Department of Health

Office of Public Health

Re: Class I Sanitary Survey
Delta Water System
PWS ID LA1065001
Madison Parish

Attachment 11

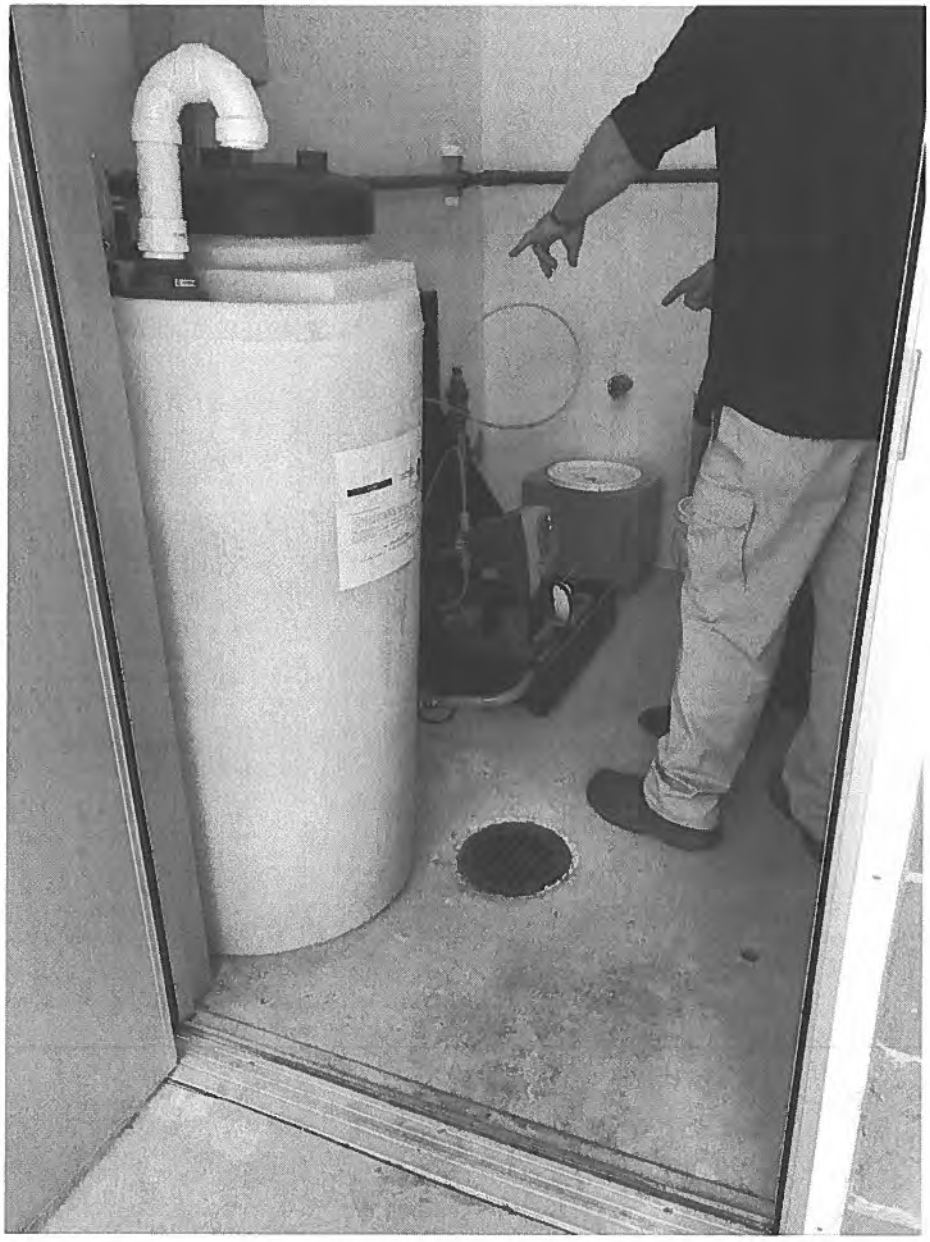
Attachment Comments: TP007, DISINFECTION WELL 7 R1473: The pumps for the chemical application of the ammonia sulfate and polymer are below the level line of the chemical within the feed tanks. The pumps must be placed in a position of positive pressure above the highest possible chemical level line of the feed tanks.
